**RE: The Confederated Tribes of Coos, Lower Umpqua and Siuslaw Indians'  
Comments on the Draft Environmental Impact Statement for Docket  
Numbers CP17-494-000 and CP17-495-000, Jordan Cove LNG Terminal and  
Pacific Connector Pipeline Projects**

**TR6 Confederated Tribes of Coos, Lower Umpqua and Siuslaw  
Indians, M. Corvi, page 1 of 39**

Figure 10.4.1 from Application to the Oregon Department of State Lands for a removal and fill permit APP0060697 showing the pipeline routes.

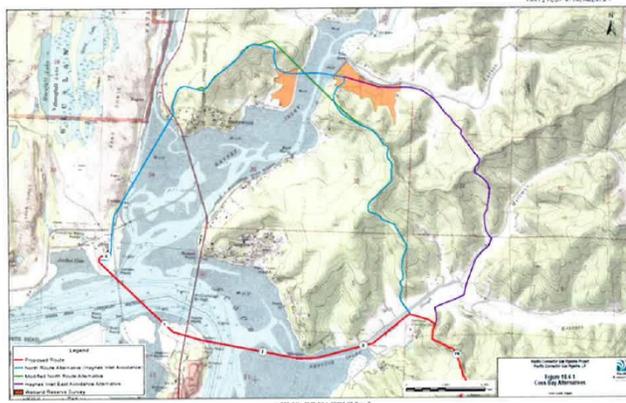
- Consistency with FERC Wetland and Waterbody Construction and Mitigation Procedures:** As stated above, the DEIS fails to adequately assess consistency of the Project with FERC’s Wetland Procedures. The Wetland Procedures provide, “The intent of these Procedures is to assist project sponsors by identifying baseline mitigation measures for minimizing the extent and duration of project-related disturbance on wetlands and waterbodies. Project sponsors shall specify in their applications for a new FERC authorization, and in prior notice and advance notice filings, any individual measures in these Procedures they consider unnecessary, technically infeasible, or unsuitable due to local conditions and fully describe any alternative measures they would use. Project sponsors shall also explain how those alternative measures would achieve a comparable level of mitigation.” The Applicant’s plans outlined in its Wetland Compensatory Mitigation plan referenced in the DEIS fails to follow these procedures. The Wetland Procedures provide that the Applicant should “route the pipeline to avoid wetland areas to the maximum extent possible. If a wetland cannot be avoided or crossed by following an existing right-of-way, route the new pipeline in a manner that minimizes disturbance to wetlands.” The pipeline route is routed through wetlands in Coos Bay and there are no alternate routes provided in the DEIS that avoid the Coos Bay wetlands. Below is the graphic from JCEP’s application to the Oregon Department of State Lands for a removal and fill permit APP0060697 illustrating how the preferred route of the pipeline runs through the Kentuck mitigation site. The alternative routes noted in the graphic have a lesser impacts on wetlands, but are not included as alternatives in the DEIS.

The provisions in the Wetland Guidance call for installations associated with extra work areas and access roads states that the applicant should “[l]ocate all extra work areas (such as staging areas and additional spoil storage areas) at least 50 feet away from wetland boundaries, except where the adjacent upland consists of cultivated or rotated cropland or other disturbed land.” The plans for the installation of the gas pipeline in the Kentuck mitigation do not minimize disturbance to wetlands. Below is the graphic from JCEP’s application to the Oregon Department of State Lands for a removal and fill permit APP0060697 showing the construction techniques for the proposed “new and improved levee” to be constructed as part of the Kentuck wetland mitigation plan. The area under the 12’ wide levee top labeled “access road” demonstrates 11 consecutive 12” lifts of cement treated soil as forming the bulk of the structure. This road is needed to allow heavy equipment to access works areas where the Applicant will install the portion of the pipeline to be buried in the Kentuck slough and install and access the drill pad for the Coos Bay East Horizontal Directional Drilling pipeline entry point at the Kentuck mitigation site. This is inconsistent with the Wetland Guidance and should be disclosed and addressed in the FEIS.
